RECORD OF DECISION

Old Moreau Dredge Spoil Area
State Superfund Project
Moreau, Saratoga County
Site No. 546040
March 2012

Prepared by
Division of Environmental Remediation
New York State Department of Environmental Conservation

Figure 2
Remedial Findings and Proposed Remedy

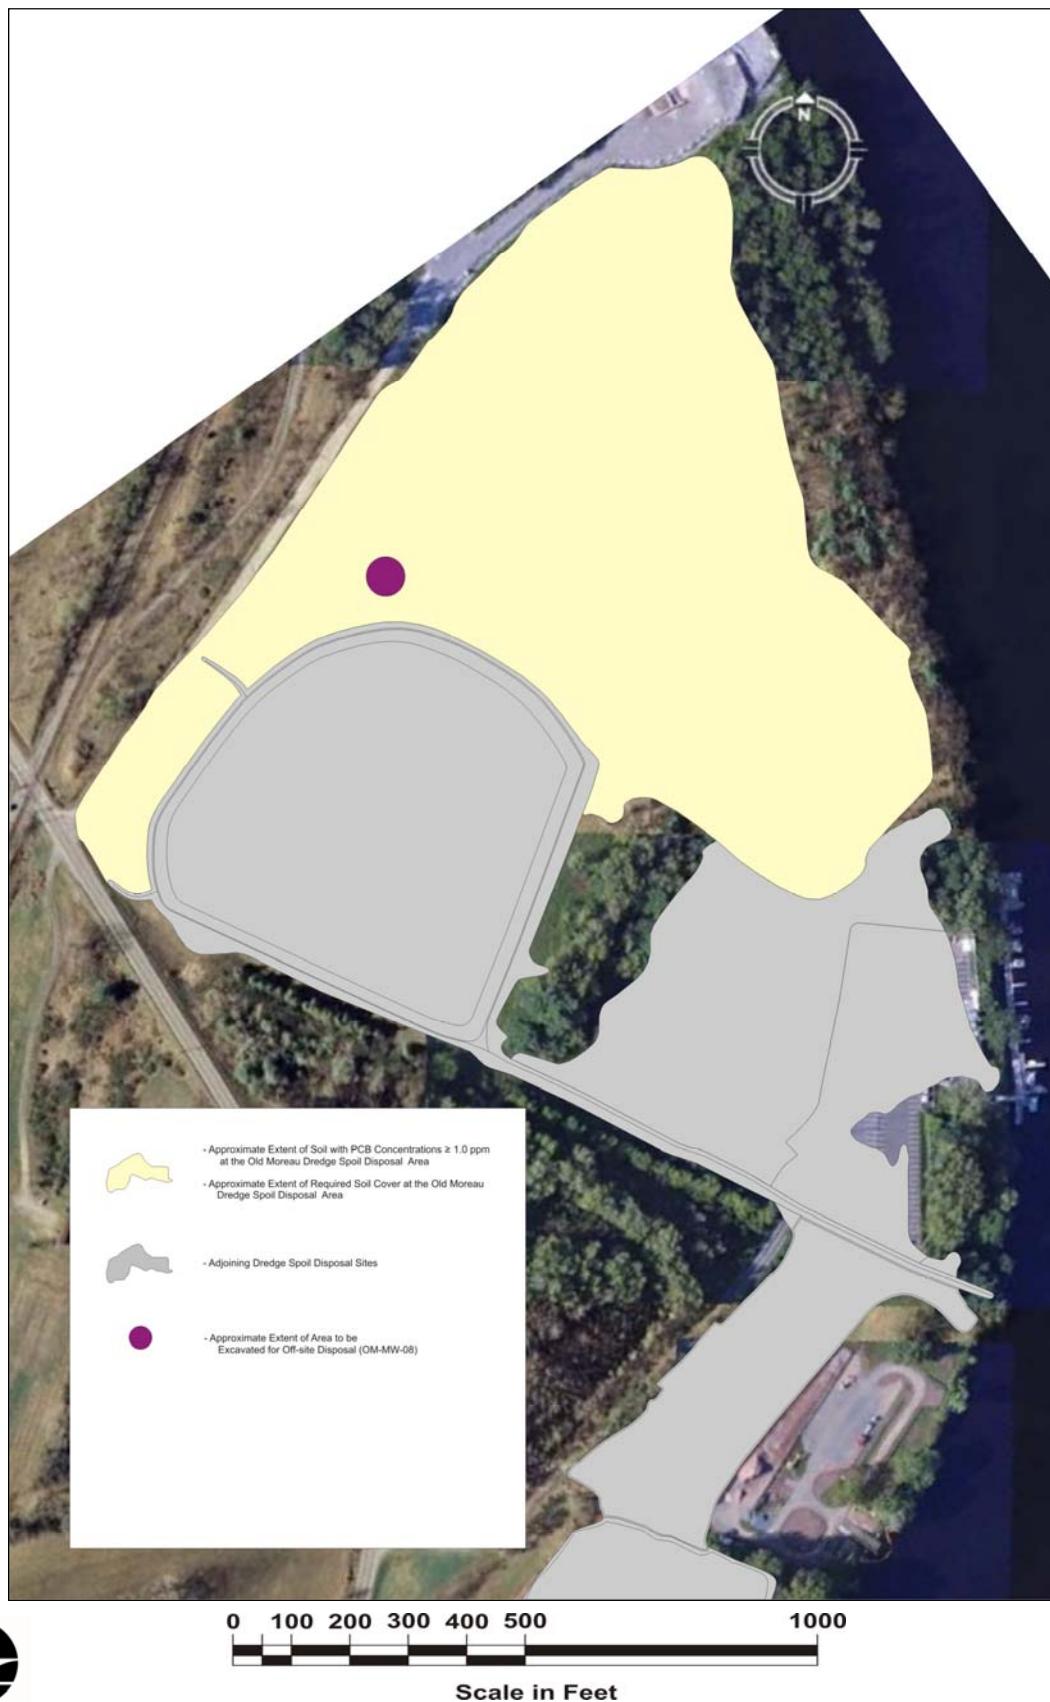
COMMENT 17: *The capping portion for the proposed remedy for the Old Moreau Site should use a statistical approach to determine the surface soil areas for capping.*

There were 215 soil samples collected from the upper one foot of soil at the Old Moreau dredge spoil Site as part of the RI. As discussed, the recalculated 95% UCL on the mean PCB concentration in these surface soil samples (see Comment 15) is 0.57 mg/kg or 0.73 mg/kg (upper 6-inches) and 0.56 mg or 0.74 mg/kg (upper one-foot). These levels are well below the 25 ppm SCO for restricted industrial, and even below the 1 ppm commercial SCO cited in the PRAP. Hence, the existing soil cover meets the remedial action objectives regardless of whether the PCB SCO is set at 25 ppm or 1 ppm for surface soils.

RESPONSE 17: The Department disagrees, and believes that the approach in remedy selection was to evaluate the cover of the entire area containing dredge spoils. However, the commenter's suggestion will be taken into account in design when finalizing the actual area to be covered. Existing portions of the site which may already meet the cover criteria to be established in design may not need an additional soil cover.
